**DEADLINE 8 RESPONSE  
KENT DOWNS AONB RESPONSE TO  
APPLICANT'S SUBMISSIONS AT DEADLINE 7**

**Applicant's response to Interested Parties' post-event submissions  
at Deadline 6 (Doc 9.177)**

**9.177 Applicant's responses to Interested Parties' post-event submissions at  
Deadline 6 [[REP7-188](#)] in respect of ISH 9**

Figure 1 – Extract taken ES, Figure 8.33 Ancient Woodland Impacts, page 2 of 6

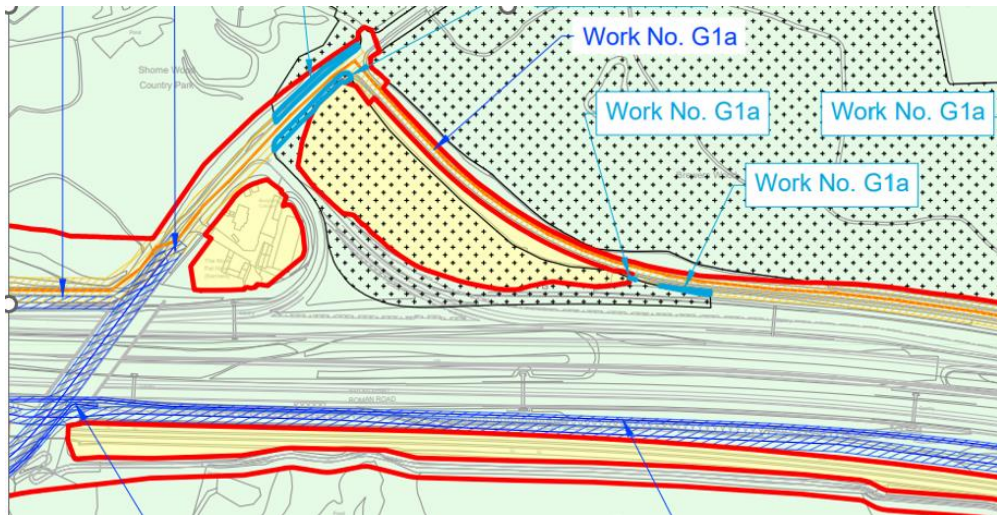
In respect of land east of the Nook Pet Hotel and Broughurst Cottage, the Applicant advises that '*Only a small amount of woodland is currently shown as lost, in association with the Brewers Road to A2 Mainline eastbound on slip*' and that '*As with other areas of woodland loss, further review at detailed design would seek to retain as much woodland as possible – as secured via REAC commitment LV001 [[REP6-038](#)]*'. The applicant fails to comment on the disparities between the plans identified in the AONB Unit's ISH 11 Post-event submission [[REP6-140](#)]; only extracts from the Environmental Masterplan and the Tree Removal and Retention plan are included in their response, not the plan showing Ancient Woodland loss included in the Environment Statement at Figure 8.33 Ancient Woodland Impacts ([APP-294](#)), Page 2 of 6, reproduced in Figure 1 below, which indicates significantly more woodland loss than is shown on the Tree Removal and Retention Plan (Figure 7.24. of 6.2 Environment Statement, [APP-261](#)). Document 9.171 Utility working in areas of Ancient Woodland [[REP7-180](#)], submitted by the Applicant at Deadline 7, helpfully shows the extent of Ancient Woodland in this area at a large scale, and when looked at in conjunction with the Environmental Masterplan and Ancient Woodland Impacts Plan, illustrates the extent of loss of Ancient Woodland east and west of the on-slip and proposed replacement with species rich grassland.
